Project No. 2021\_154

MIDLOTHIAN ISD STADIUM ADDITIONS AND RENOVATIONS

ADDENDUM NO. 2

DATE: October 18, 2021

6 DEMOLITION FLOOR PLAN FIELD HOUSE  
1/8" = 1'-0" REF 1 / A-202

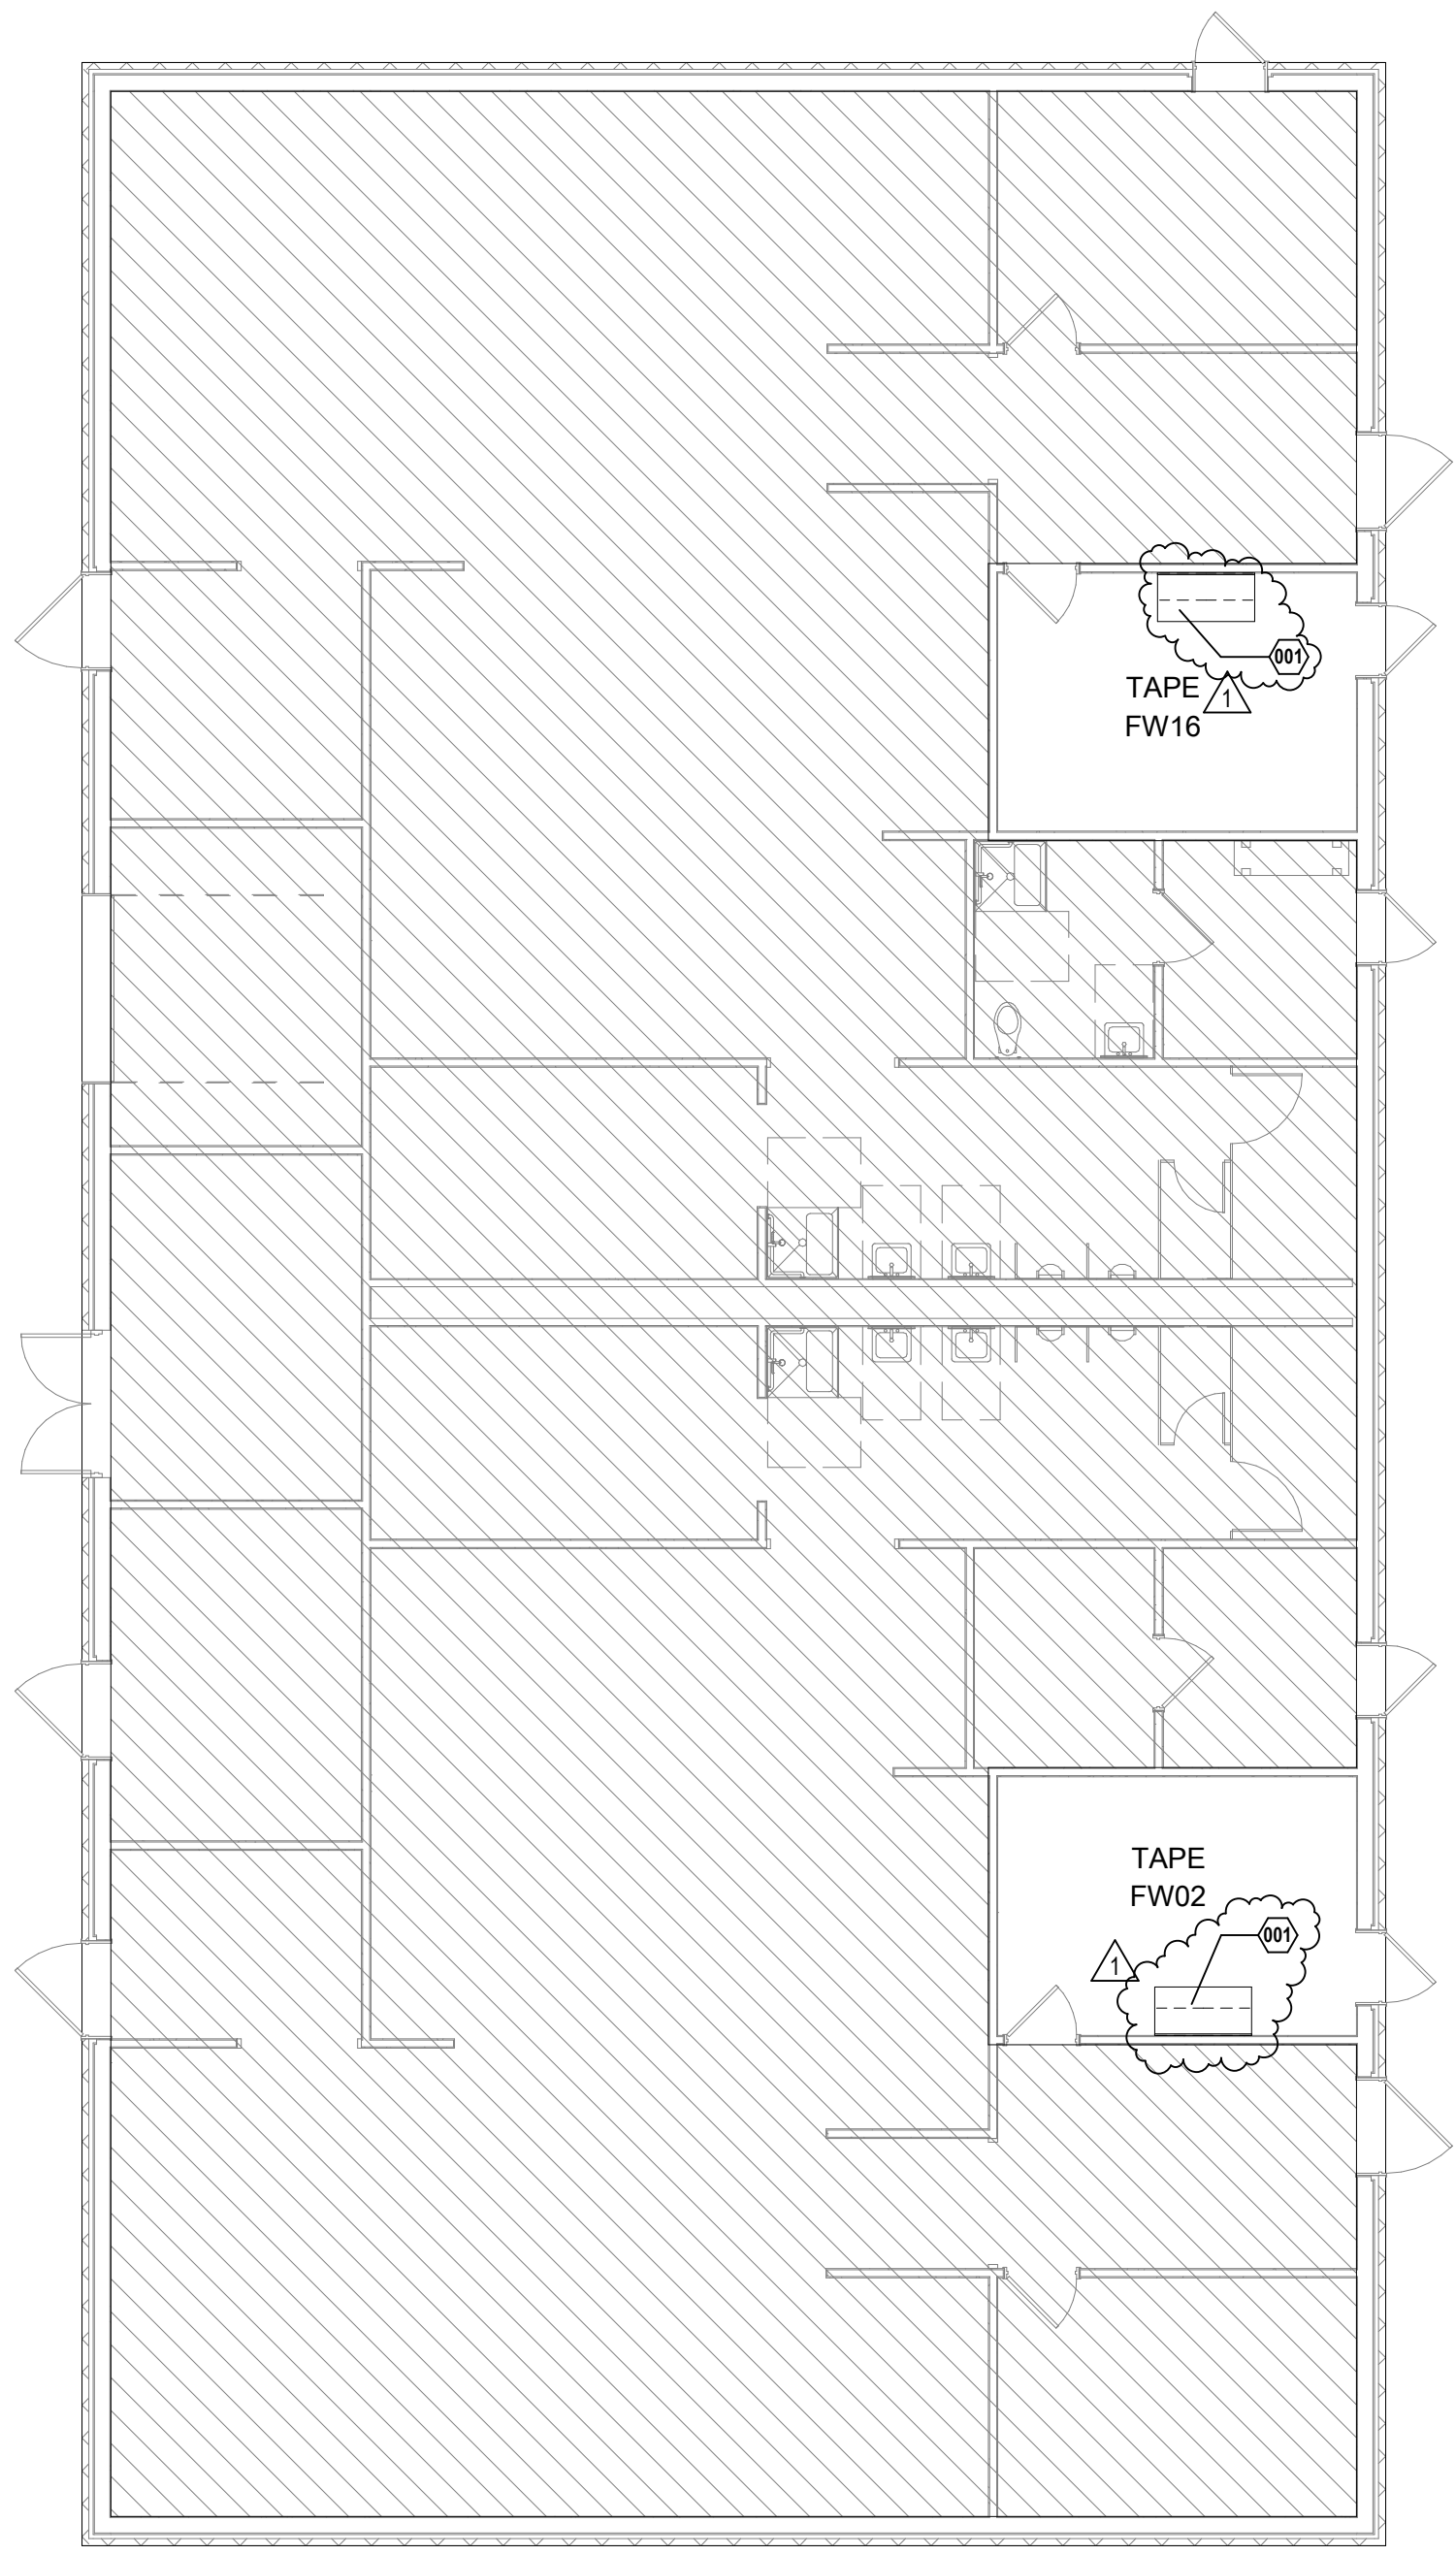
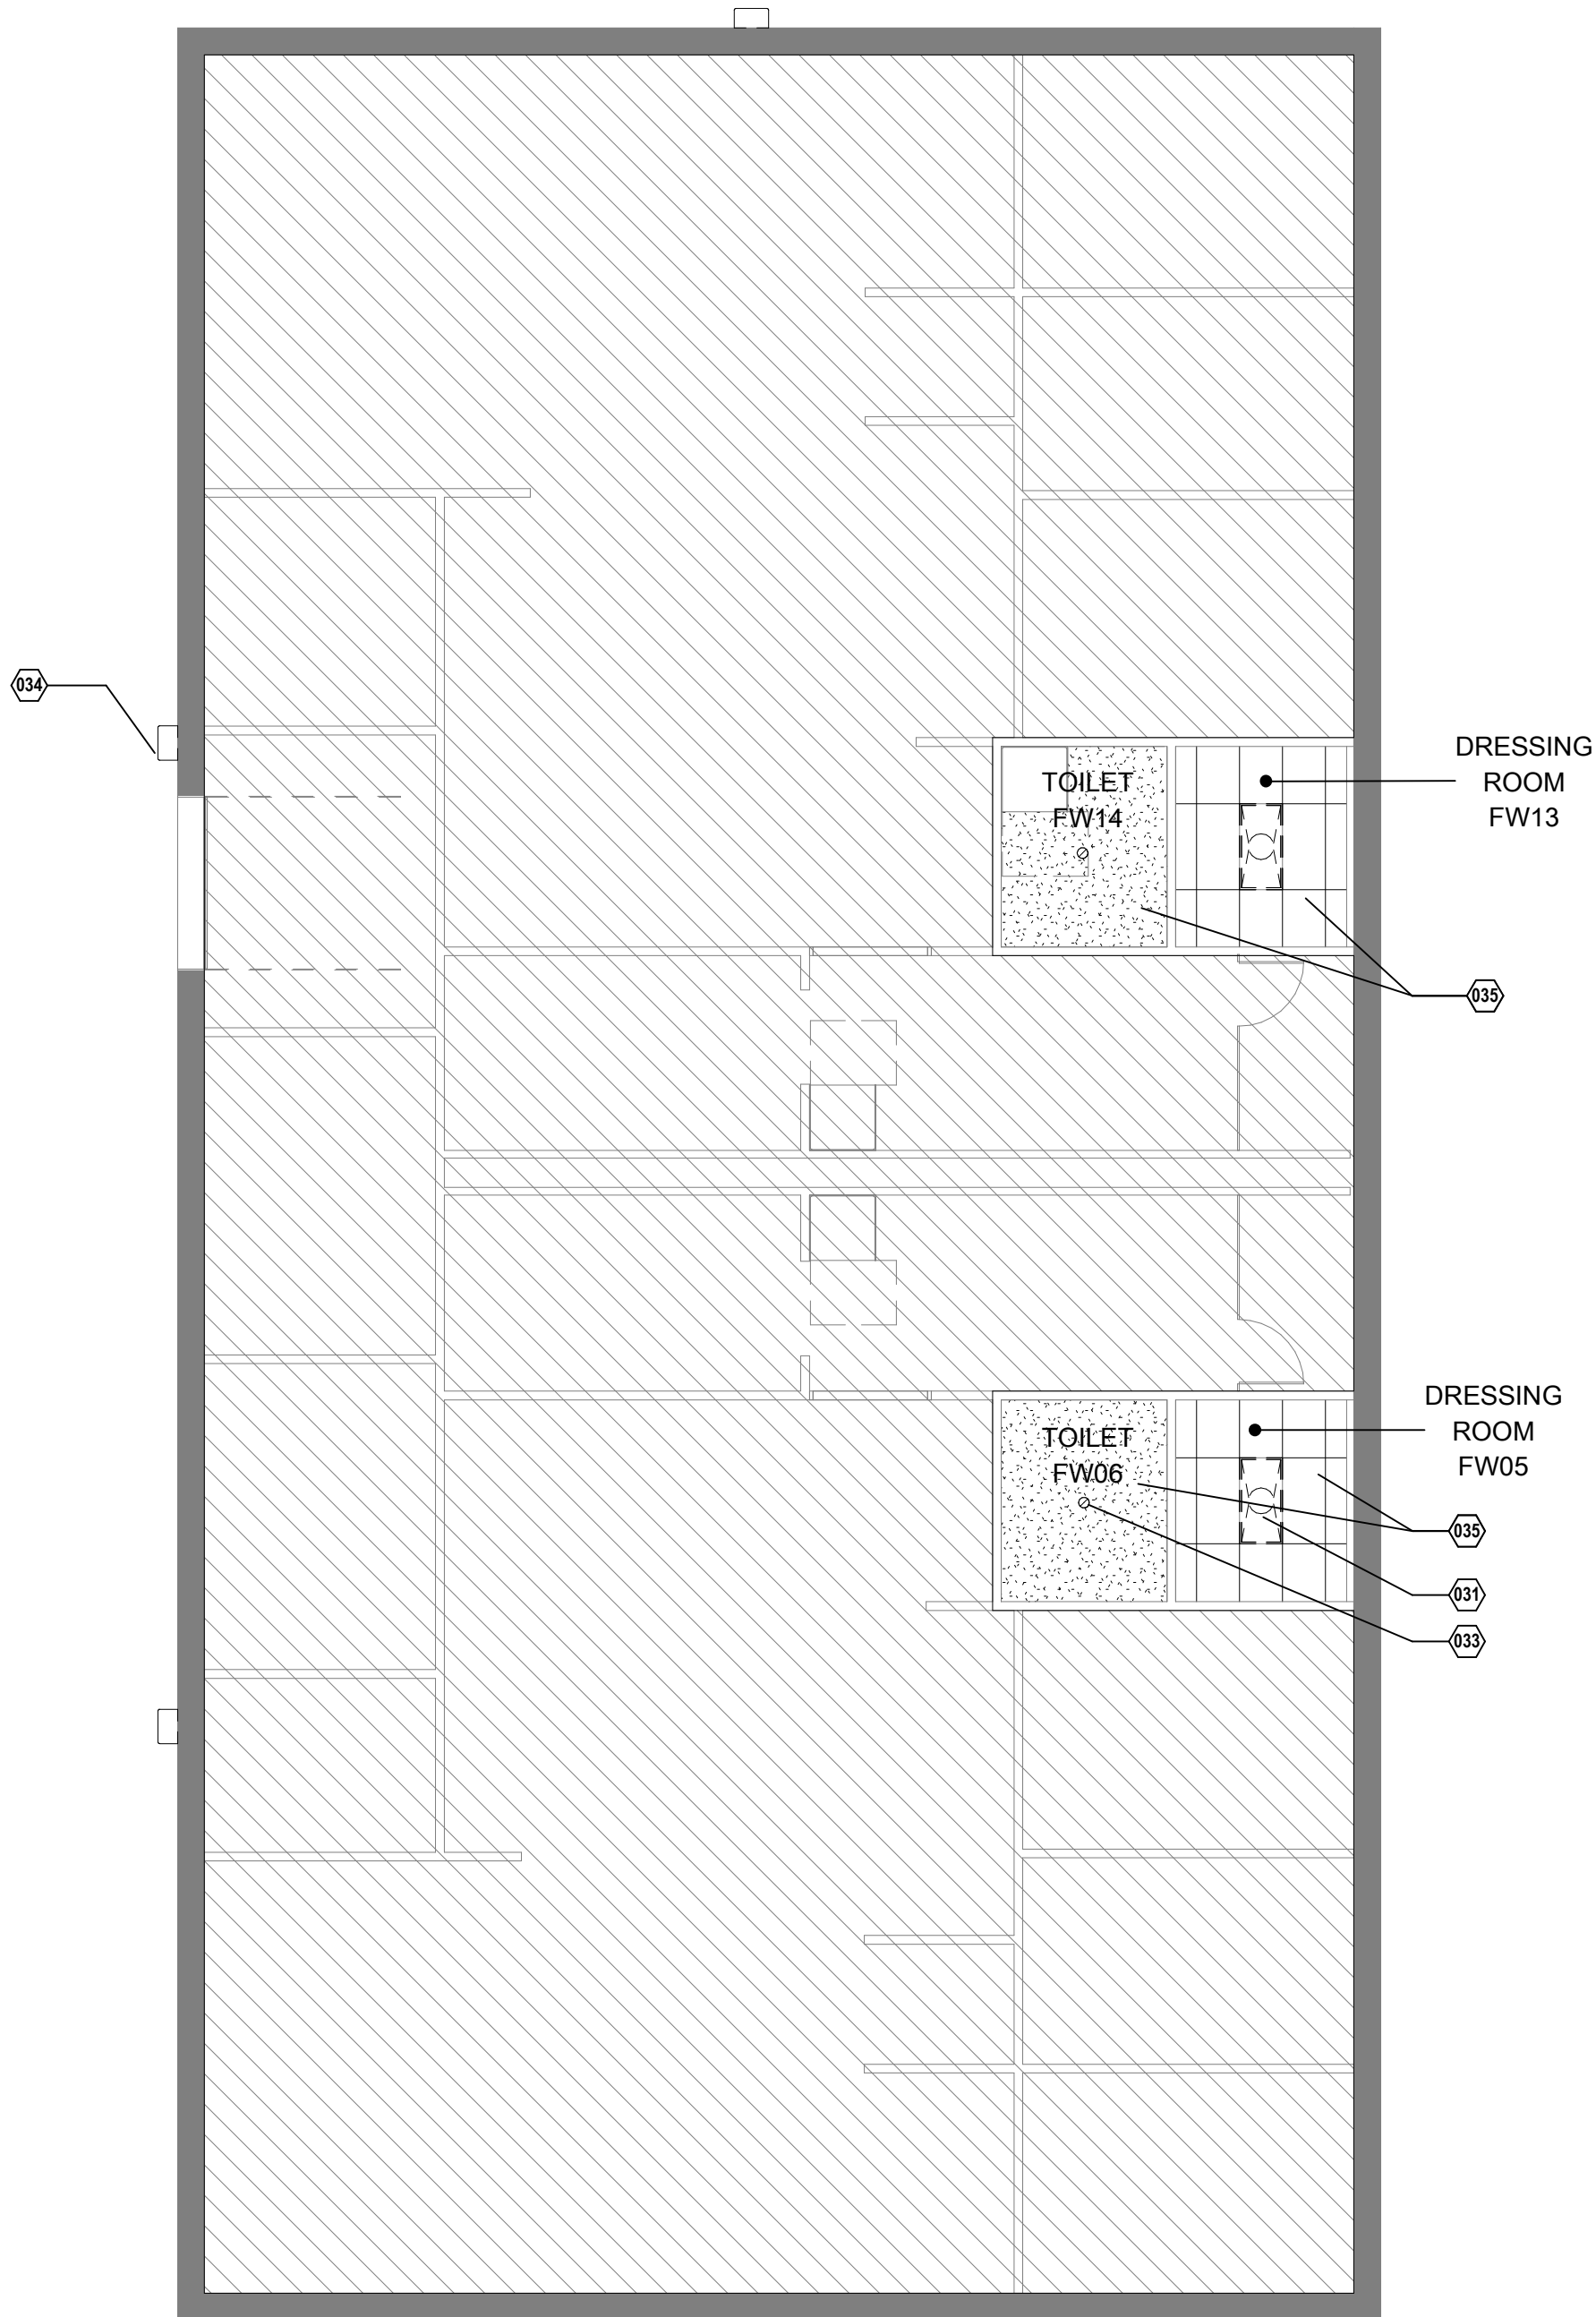
- A2.7 SHEET AD-102 DEMOLITION PLANS:  
REMOVE and REPLACE in its entirety.  
a. REMOVED upper- and lower-case work in existing tape room in field house.
